STAFF MEMO

Subject: Hammond Road, LLC (applicant/owner) – Review for acceptance and consideration of final approval for a major site plan application to construct a 6,400 square foot office and storage building with associated site improvements. The parcel is located at 0 Nathaniel Drive in the Commercial Zoning District and Groundwater Protection District. Tax Map 43 Lot 69-1

Re: Adam Vaillancourt Roofing Site Plan (Lot 43-69-1) – Drainage Review

**Re: Interdepartmental Review Map 43 Lot 69-1
Vaillancourt Roofing Site Plan**

EXISTING CONDITIONS PLAN
MAP 43 / LOT 69-1
ADAM VAILLANCOURT ROOFING & CONSTRUCTION, LLC
STONEYARD DRIVE
TOWN OF MILFORD
HILLSBOROUGH COUNTY, NEW HAMPSHIRE

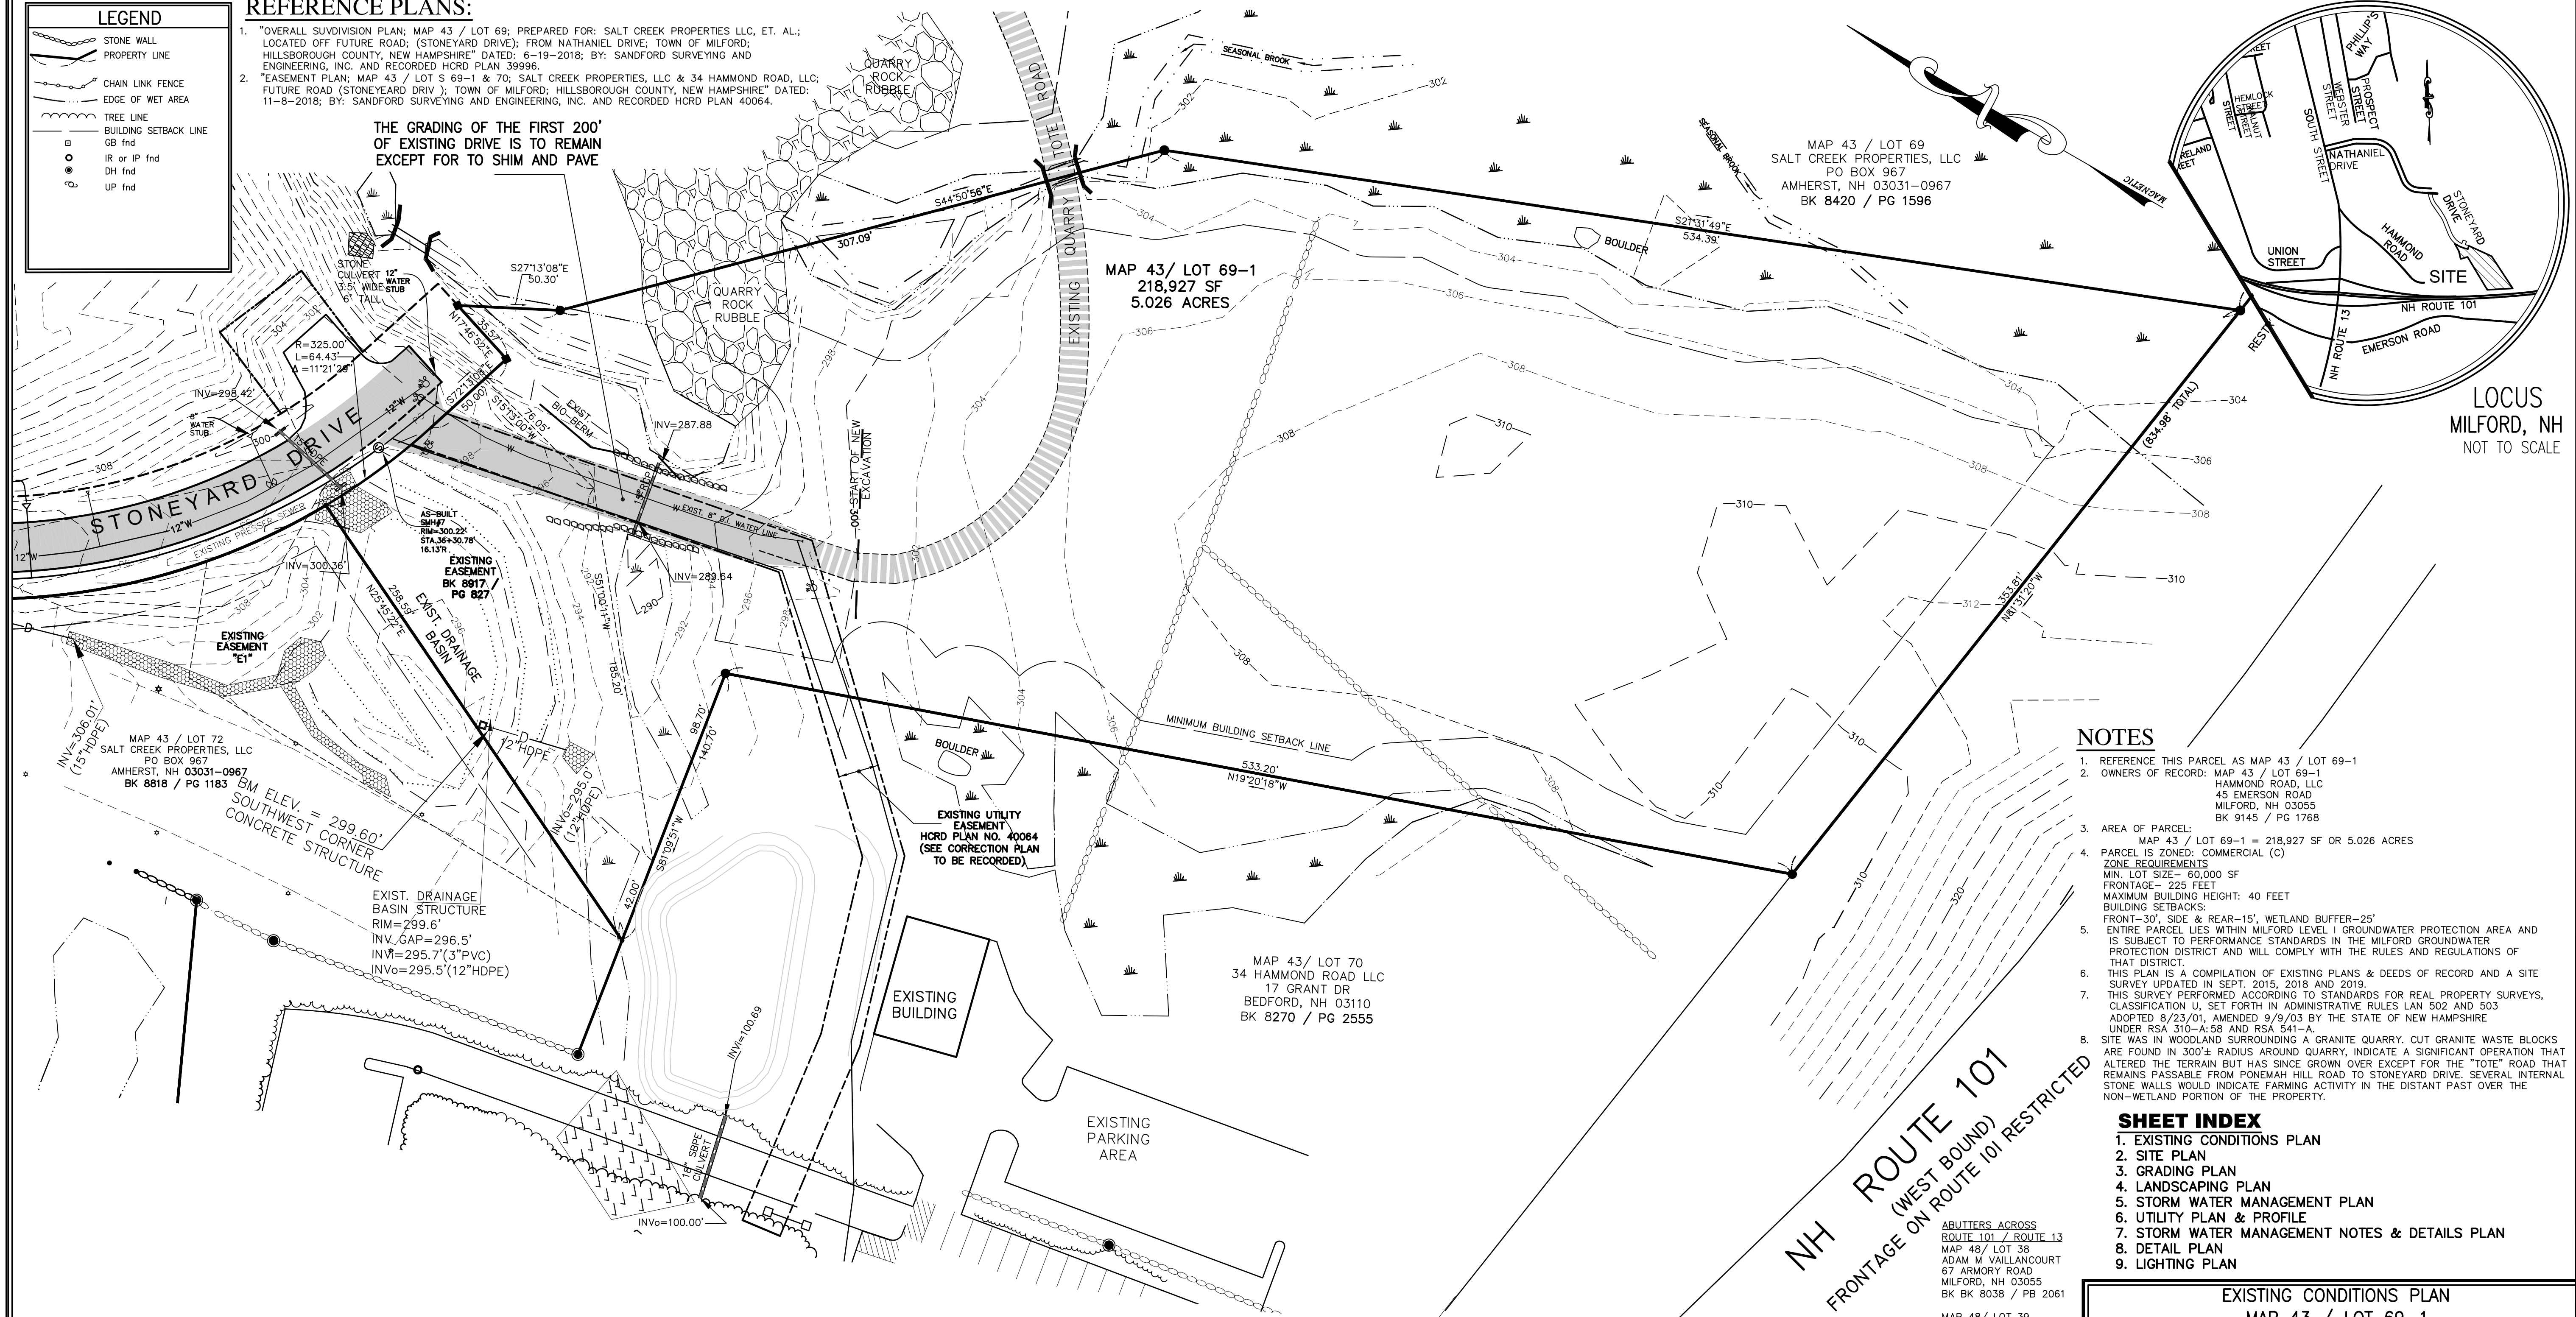
1. Sheet 1. Please confirm whether or not Stoneyard Drive & the internal site will be paved.
2. Sheet 2. Parking Requirements Note 7 states the garage/storage area to be 5,100 square feet however the plan indicates the garage area is 2,400 square feet. Please provide clarification on the square footage of the garage/storage area.
3. Sheet 2. If the garage/storage area is in fact 2,400SF please correct the calculation to state 2,400 SF / 1 per 1,000 SF = 2.4 spaces and update the Parking required to 15 spaces.
4. Sheet 2. Please correct Note 10 to state Groundwater Protection level 2 District.
5. Sheet 2. Will any improvements be made to the existing culvert located under existing drive Tote Road? Please explain why or why not.

SITE PLAN
MAP 43 / LOT 69-1
ADAM VAILLANCOURT ROOFING & CONSTRUCTION, LLC
STONEYARD DRIVE
TOWN OF MILFORD
HILLSBOROUGH COUNTY, NEW HAMPSHIRE

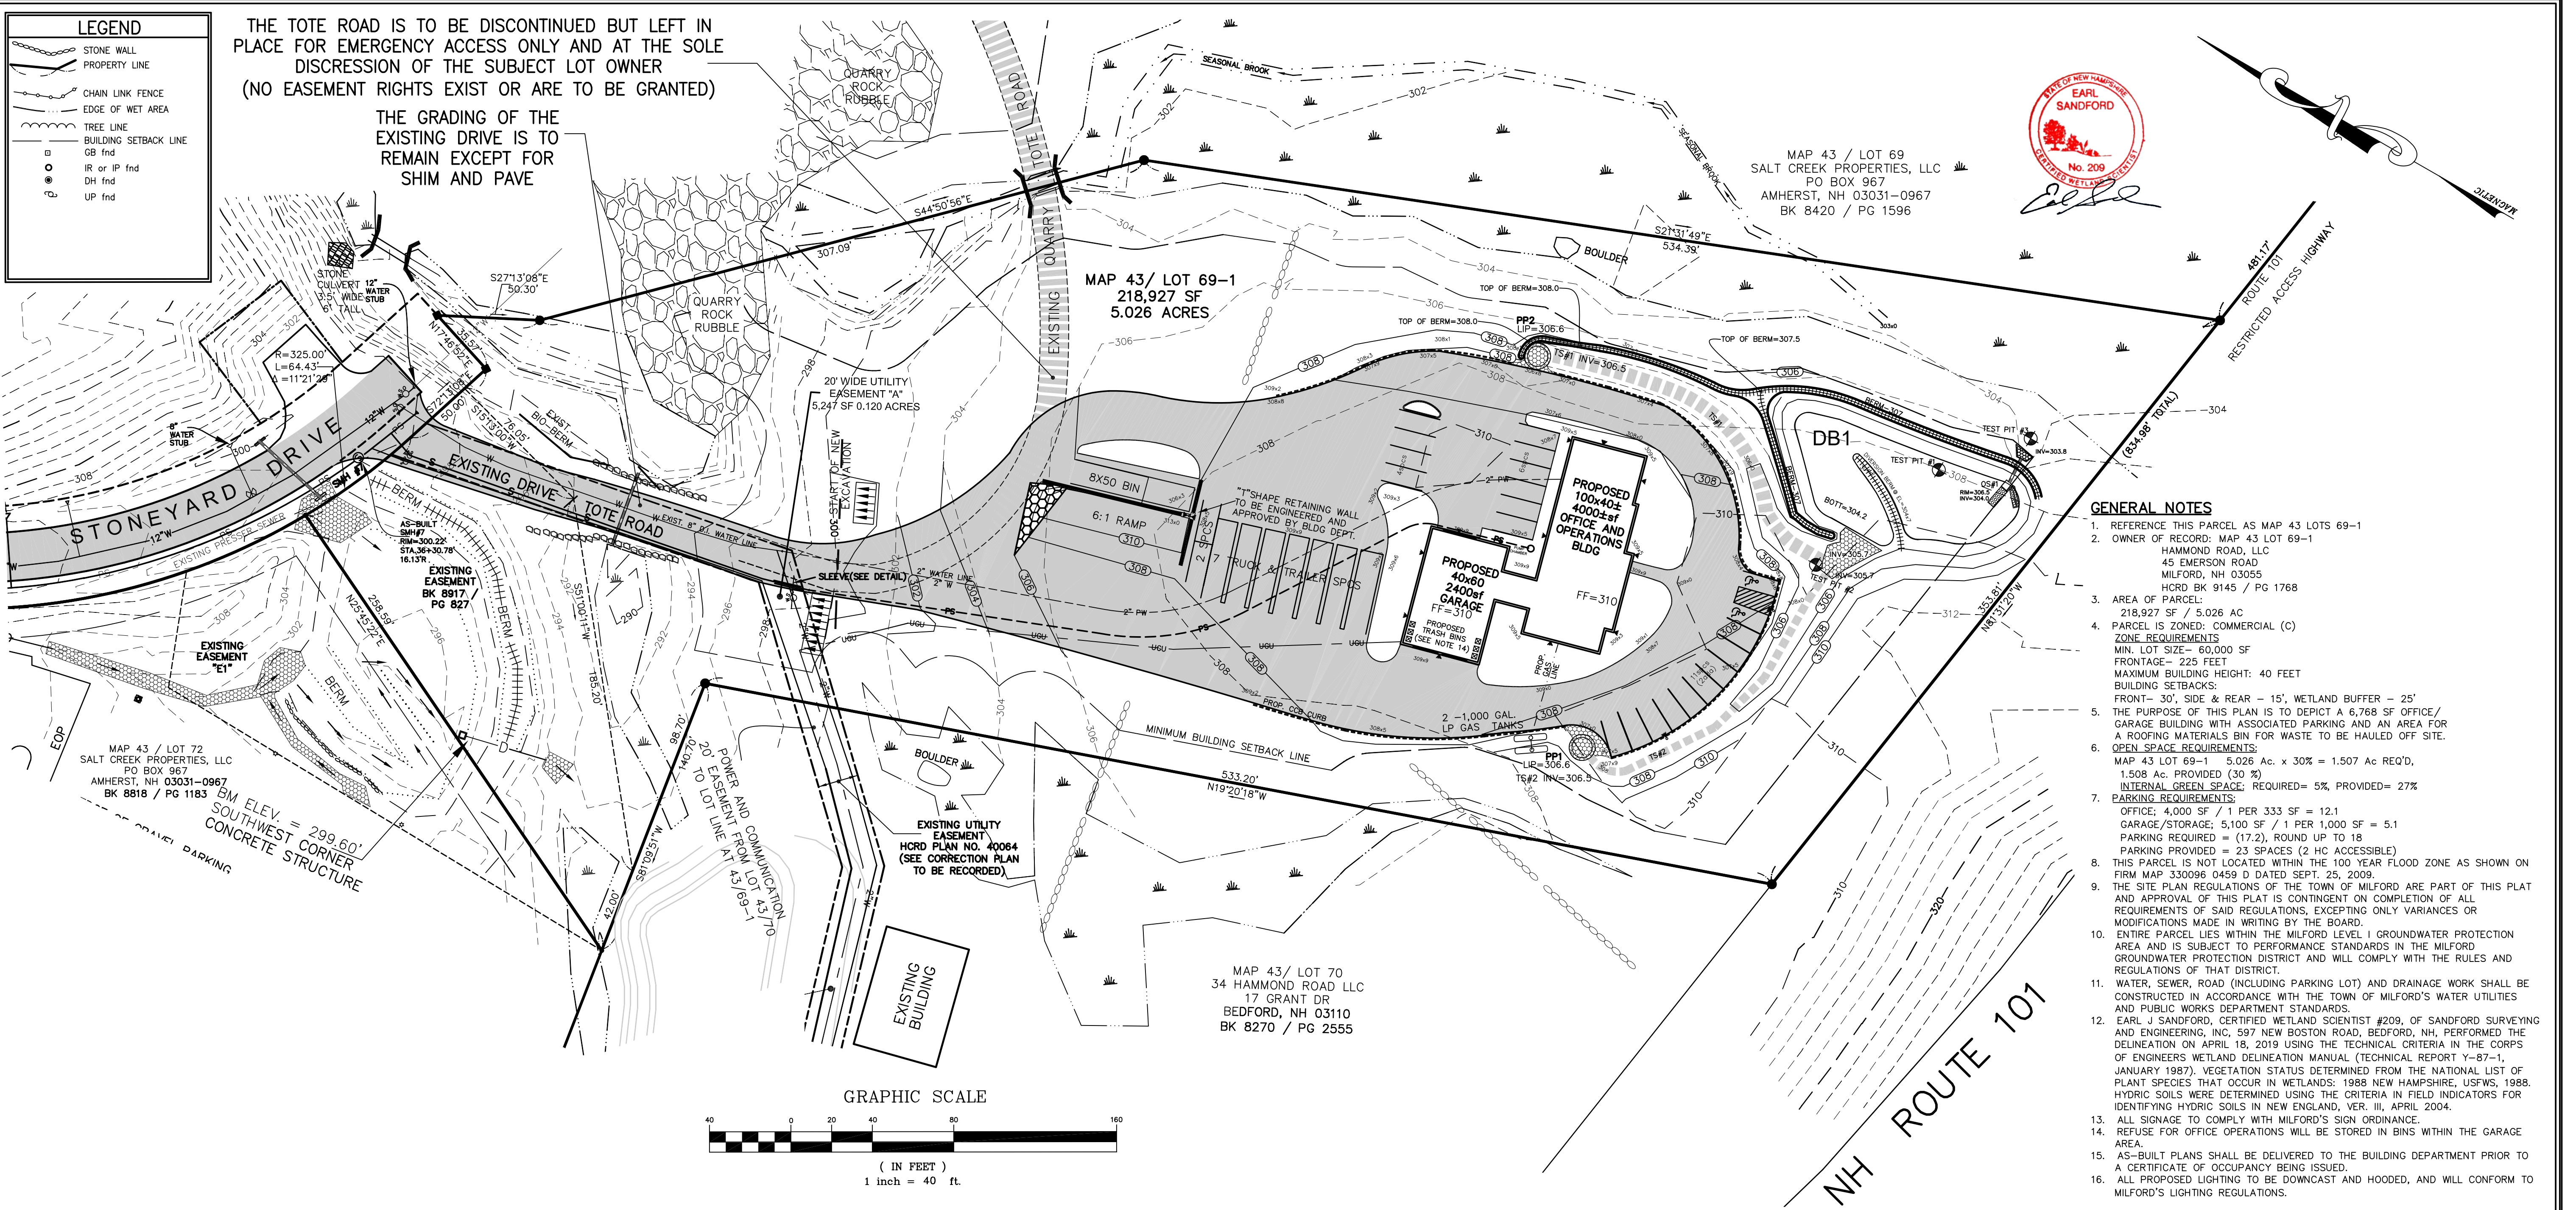
The project proposes to provide 22 total parking spaces whereas 15 spaces are required. The calculation is based on the square footage of the office space and square footage of the storage space as noted on sheet 2 of the plan.

LANDSCAPE PLAN
MAP 43 / LOT 69-1
ADAM VAILLANCOURT ROOFING & CONSTRUCTION, LLC
STONEYARD DRIVE
TOWN OF MILFORD
HILLSBOROUGH COUNTY, NEW HAMPSHIRE

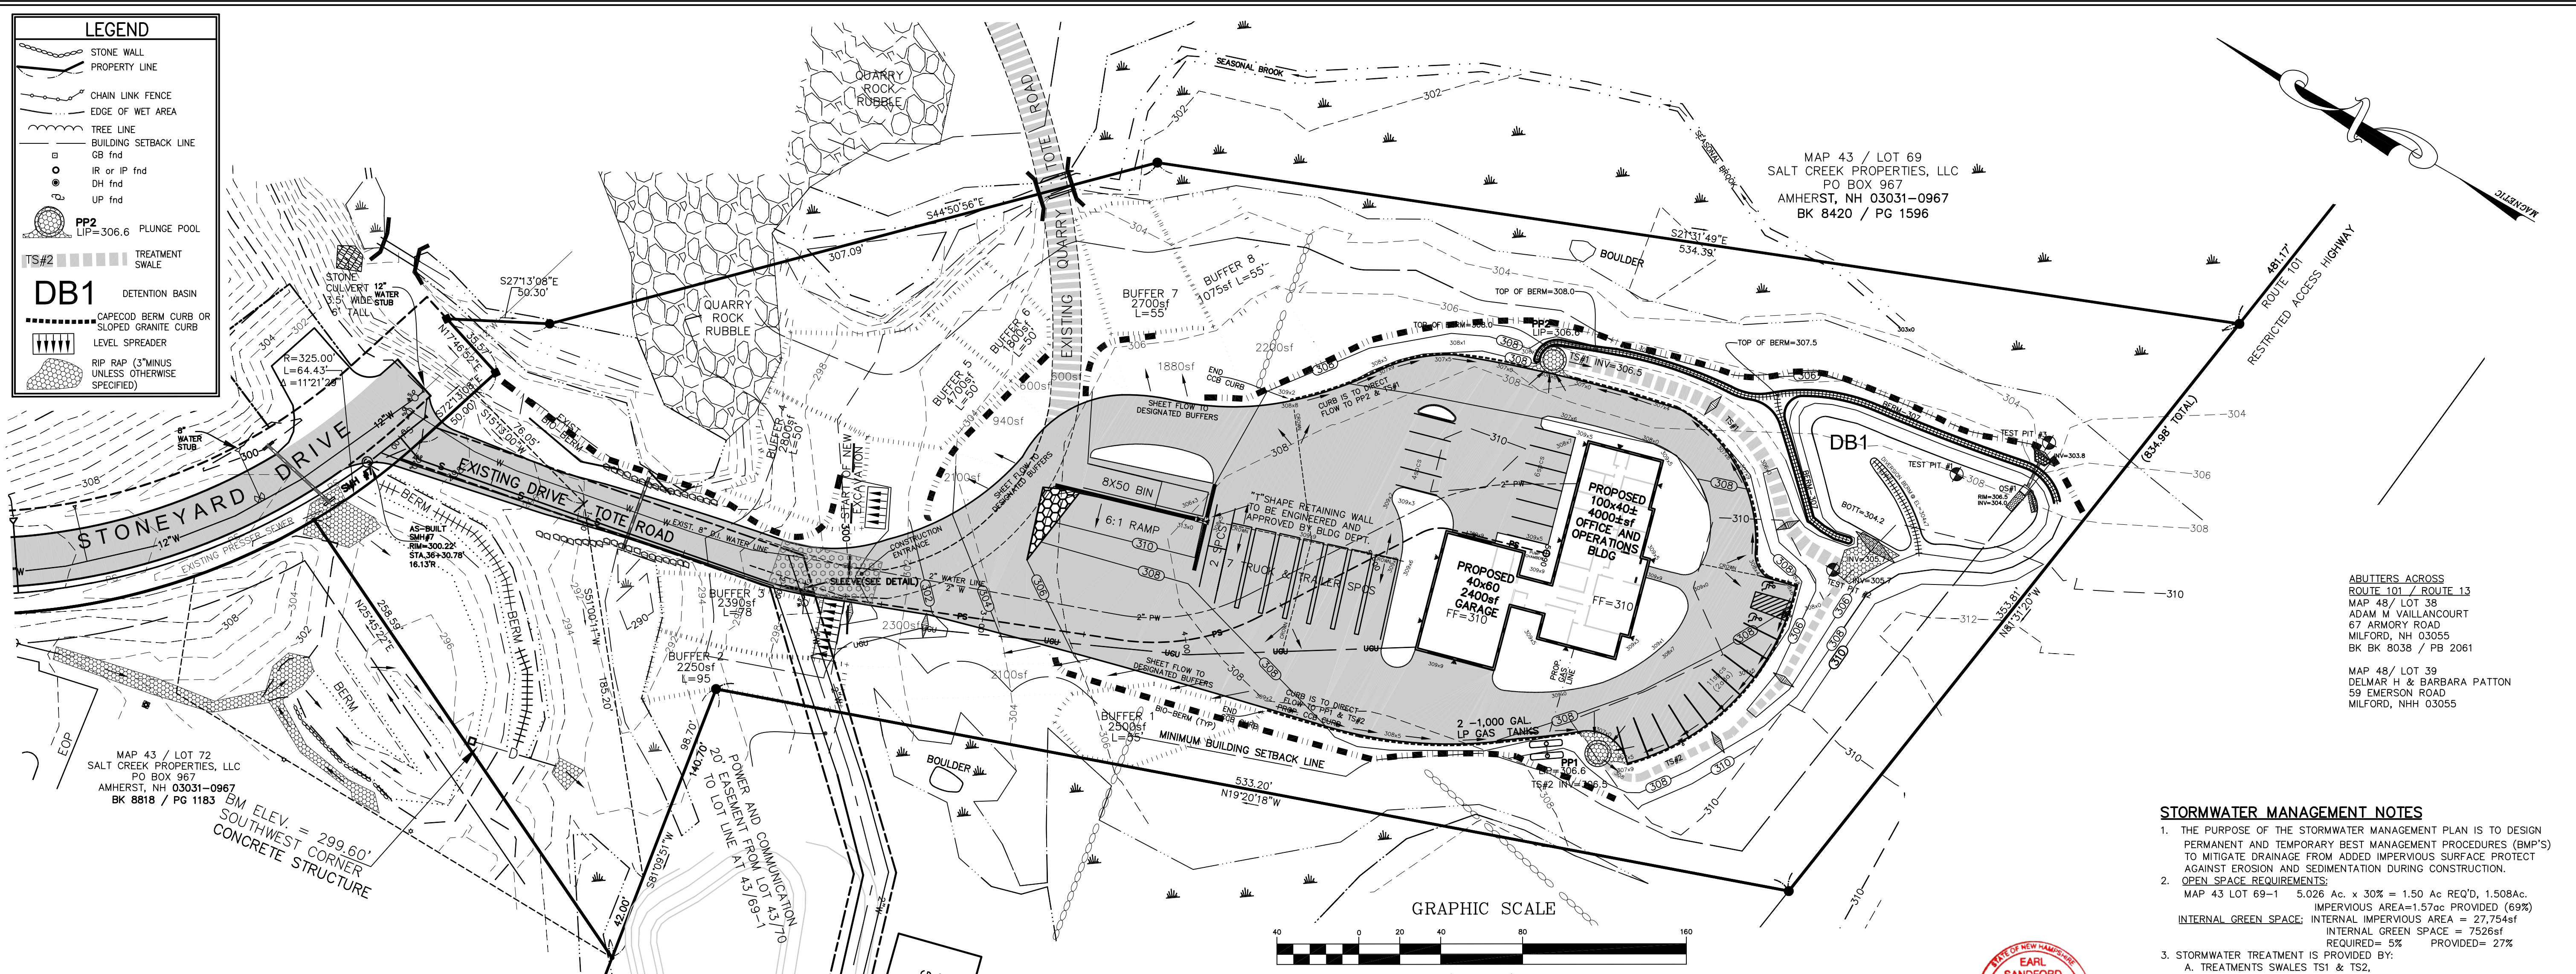
6. Sheet 3. Please correct the note on the plan that states “Buffer #***”. *Addressed.*
7. Sheet 3. Provide a legend/key to define all symbology on the plan. *Addressed.*
8. Sheet 4. Pursuant to Section 6.08.8.A of the Development Regulations, please confirm that all plant stock meets the ANSI Z60.1 standard.
9. Please confirm that power on site will be located underground.
10. Please clarify on-site flow of traffic. Add directional arrows or any appropriate signage etc.
11. General Comment – will the general public be frequenting the site?
12. Please add a note detailing applicable Impact Fees.
13. Groundwater Protection District. Zoning Ordinance Section 6.01.3.C.2 - Please confirm the amount of impervious surface that will result from this project.
14. Signage. If a sign is intended to be located on site please provide a Signage Plan per the Development Regulations Section 6.018.
